Access Compliance Report

Public Rights-of-Way

Intersection ID: 5905	Main Street: HELLEBORE_RD	Cross Street: PIMPERNEL_RD	Location: NW
ADA ID: E52342FB6B2A	Ramp Type: Perp	Initial Pass/Fail: Fail	Overall Compliance: No
Severity Score: 12.5			
Codes/Mitigation Info/Possible Solution		Field Measurements/Component Compliance

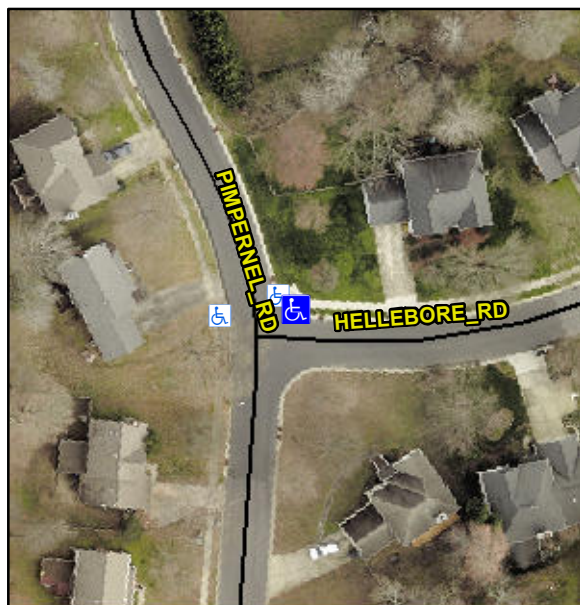
R304.2.2

Compliance	Description	Data	Compliance	Description	Data
N/A	Ramp Length (in)	47.0	No	Ramp Slope (%)	10.8
Yes	Ramp Width (in)	72.0	Yes	Ramp XSlope (%)	0.6
N/A	Flare Type LT	N/A	N/A	Flare Type RT	N/A
N/A	Flare Slope LT (%)	N/A	N/A	Flare Slope RT (%)	N/A
N/A	Flare Traversable LT?	N/A	N/A	Flare Traversable RT?	N/A
N/A	Landing Length (in)	N/A	N/A	DWS Provided?	N/A
N/A	Landing Width (in)	N/A	N/A	DWS Contrast?	N/A
N/A	Landing Slope (%)	N/A	N/A	DWS Length (in)	N/A
N/A	Landing X Slope (%)	N/A	N/A	DWS Full Width?	N/A
N/A	Landing Curb? (Y/N)	N/A	N/A	DWS Offset (in)	N/A
N/A	Shared Landing?	N/A			
N/A	Gutter Ponding?	N/A	N/A	Gutter Slope (%)	N/A
N/A	Gutter Lip Ht (in)	N/A	N/A	Gutter X Slope (%)	N/A
N/A	Painted X Walk1?	No	N/A	Painted X Walk2?	N/A
	X Walk 1 Direction	To S		X Walk 2 Direction	N/A
N/A	X Walk 1 Width (in)	N/A	N/A	X Walk 2 Width (in)	N/A
	X Walk 1 Slope (%)	4.5		X Walk 2 Slope (%)	N/A
	X Walk 1 X Slope (%)	0.0		X Walk 2 X Slope (%)	N/A

Remove & Replace Entire Ramp.
